Highways and Transportation

Application - TM/20/02749/OA

Location - Land South Of Barming Station And East Of Hermitage Lane Aylesford Kent

Proposal - Outline Application: erection of up to 330 dwellings (including 40% affordable homes), together with associated open space, play areas, and landscaping (including details of access)

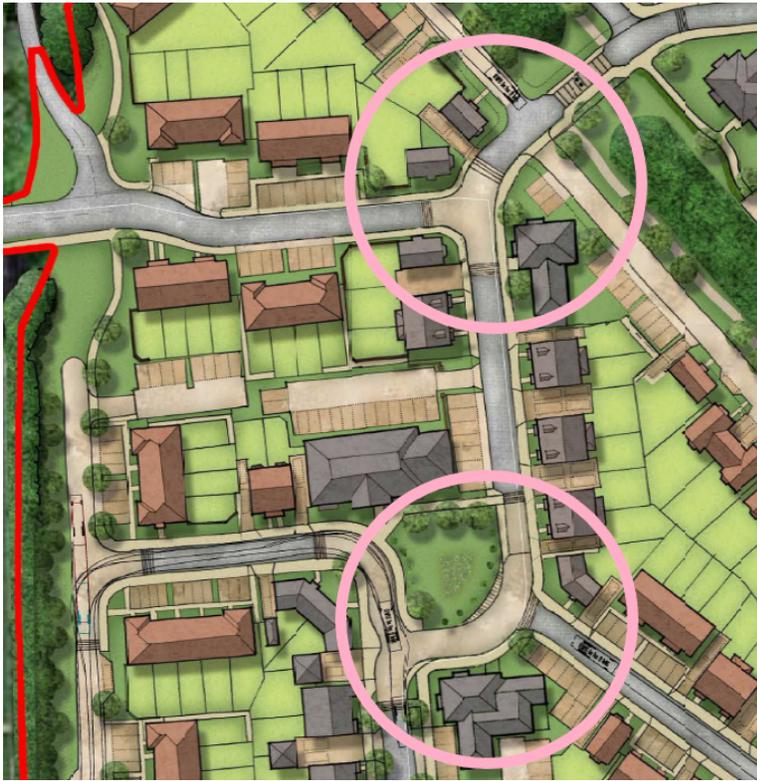
It is recommended that forward visibility splays are introduced, and measures introduced to provide an approaching driver adequate vision before entering the junction.

The safety auditors' comments were made in reference to drawings, traffic flows and a site visit and there is no revised plans or evidence to support the designer's response. It can be seen from the Google extract below that a HGV or refuse vehicle which is unable to fully turn into the access due to opposing traffic, will either overhang the junction or be unseen seen by subsequent left turning traffic from Hermitage Lane, leading to potential collisions. It is considered that additional space is needed on the left turn in.

Please provide a revised drawing showing the visibility required for pedestrians and the extent of the vegetation that needs to be removed to address comment 3.2.1 and also the footway along the south side of the access road to address point 3.2.2.
